# Access Compliance Report

## Public Rights-of-Way

### (Curb Ramps)

Intersection ID: 26386	Main Street: OVER_STREAM_LN	Cross Street: PROVIDENCE_HILLS_DR	Location: E
ADA ID: 256BB2E28807	Ramp Type: BlendTrans2	Initial Pass/Fail: Pass	Overall Compliance: No
Severity Score: 0			
Codes/Mitigation Info/Possible Solution		Field Measurements/Component Compliance

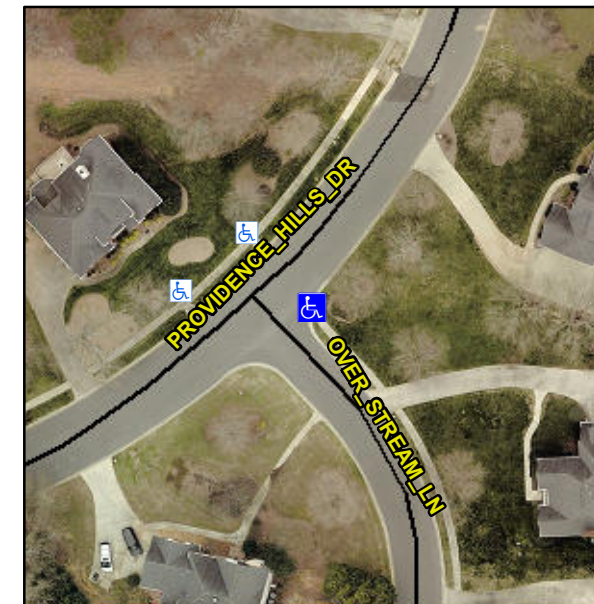
**Not Found, R304.2.3, R305.2**

**Remove & Replace Curb Ramp With Two New Directional Ramps or Equivalent.**
